PRODUCT CHANGE NOTICE

PCN#06-001**NOTIFICATION DATE: April 12, 2006****MODEL AFFECTED:**

Case Styles: DZ883, DZ885, DZ943, DZ944, DZ1034
Model Prefixes: MCA, MCA1, SCA, QBA, BDCA, BDCA1

Sample Case Style Drawing DZ883 including new dimensions

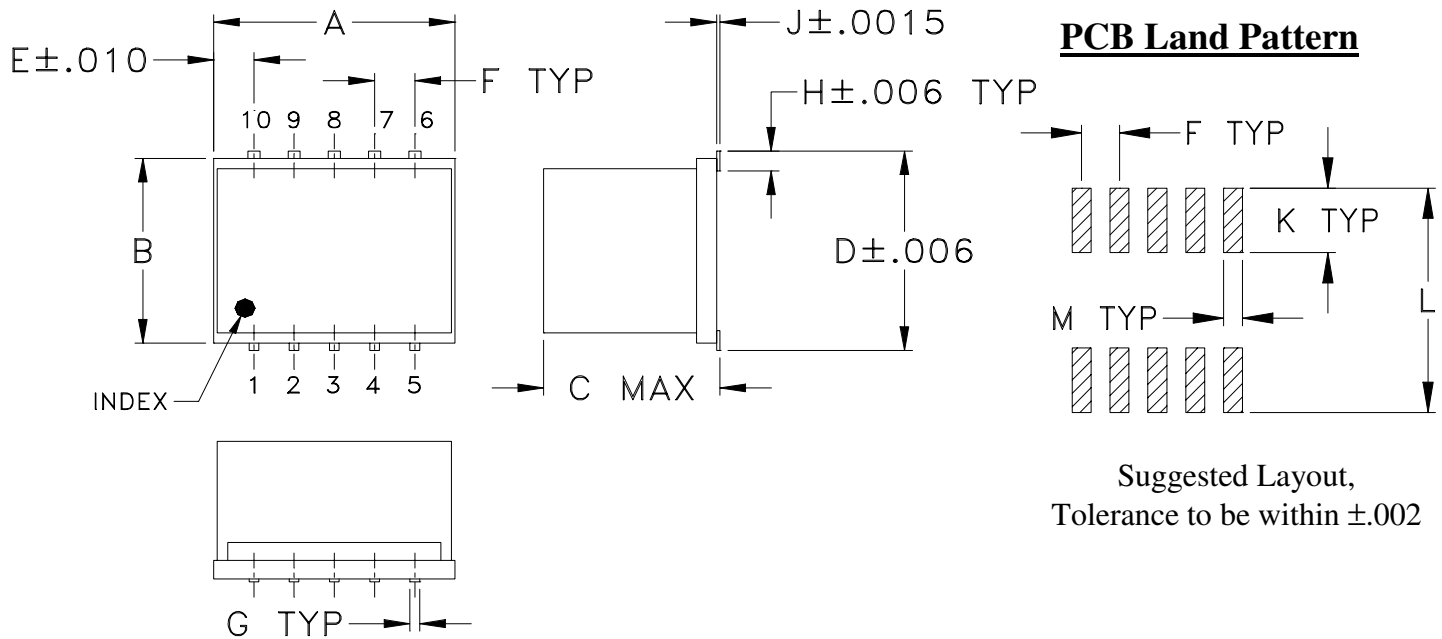
<i>Existing</i>	<i>New /Change</i>
<i>Dimension D</i>	<i>0.274 inch/ 6.96 mm, +/-0.008"</i>	<i>0.262 inch/6.66 mm, +/-0.006"</i>
<i>Dimension H</i>	<i>0.057 +/- 0.010 inch</i>	<i>0.027 +/- 0.006 inch</i>

Change of form only. Customer use is not affected and recommended solder footprint is unchanged.

To tighten the tolerance of the dimension specifications of the outline drawing.

New manufacturing lots after April 1, 2006. Existing stock to remain as previous.
